Form C-103
Revised July 18, 2013

Plug and Abandon

Wellname: **RESLER YATES STATE #382**

Action 524503

RESLER YATES STATE #382 P&A Schematic

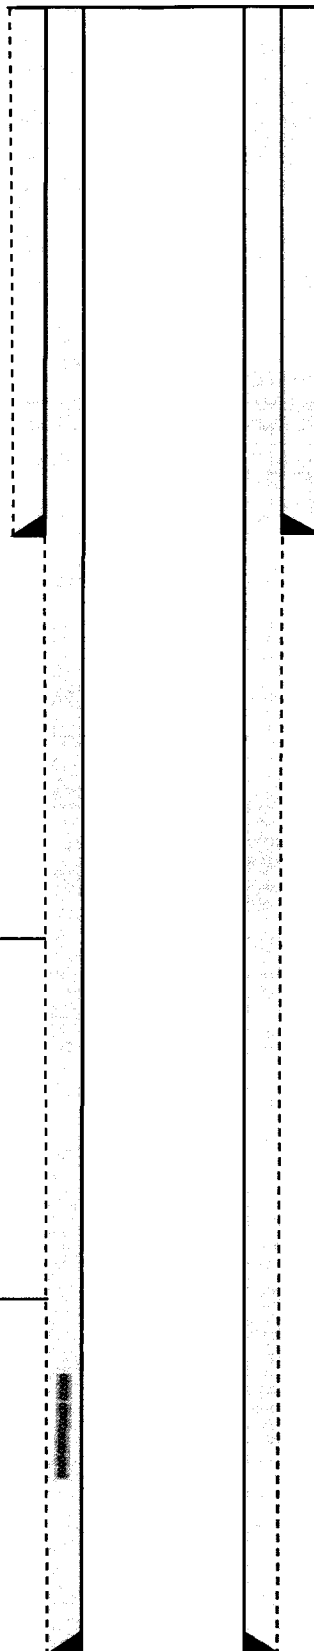
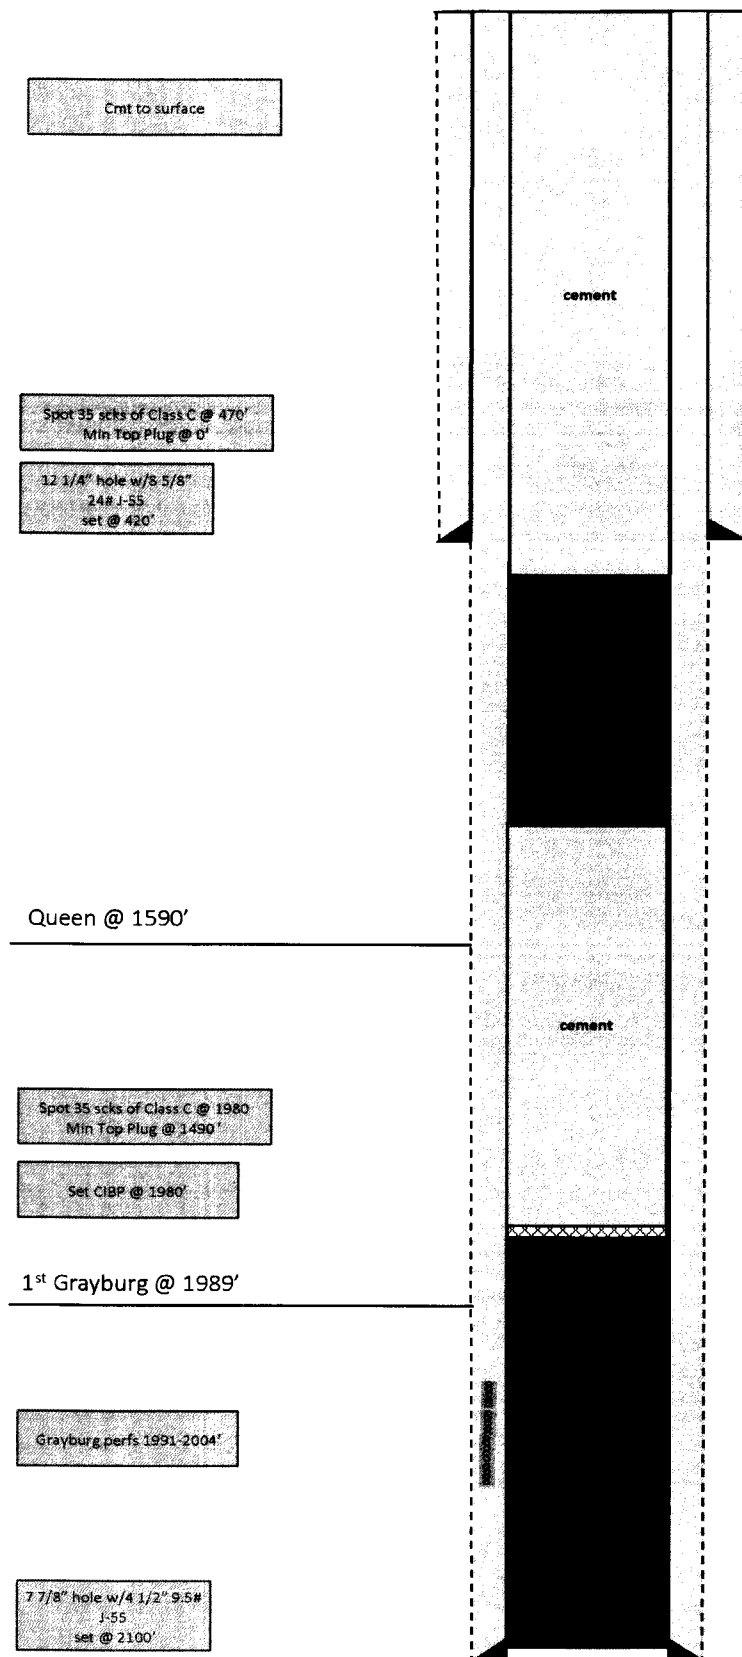
Created By	Condition	Condition Date
loren.diede	Notify the OCD inspection supervisor via email 24 hours prior to beginning Plug & Abandon (P&A) operations.	11/14/2025
loren.diede	NMOCD does not consider this well to be within the LPCH restricted area and an above ground P&A marker is required. NMOCD requires that plug(s) be added to cover the 7 Rivers = (960') and Yates = (600') formation tops. Submit photo and GPS coordinates of the P&A marker with the final P&A reports. The API# on the marker is to be clearly legible. Run CBL from CIBP to surface. Submit the CBL tif file to NMOCD for uploading into the Well Log File.	11/14/2025
